SIB 51 09 22

SQUEAKING NOISE FROM DRIVER EXTERIOR MIRROR WHEN FOLDING IN AND OUT

E-Series	Model Description	Production Date	Affected Option Code
G26	4 Series Gran Coupe	From Start of Production (7/2021) thru approx. 5/2022	All

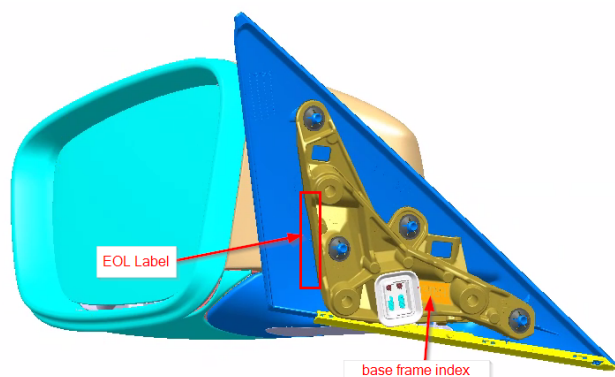
The gap (4 & 5) between the base and cap of the exterior mirror is too small due to manufacturing oversight.

This tight gap only applies to the driver’s side mirror, because the passenger mirror was produced with different tooling.

Replace the driver’s exterior mirror assembly.

- The painted mirror cap will be reused from the original mirror

Note: The exterior mirror will need to be replaced with (revision Index (A1) 08).
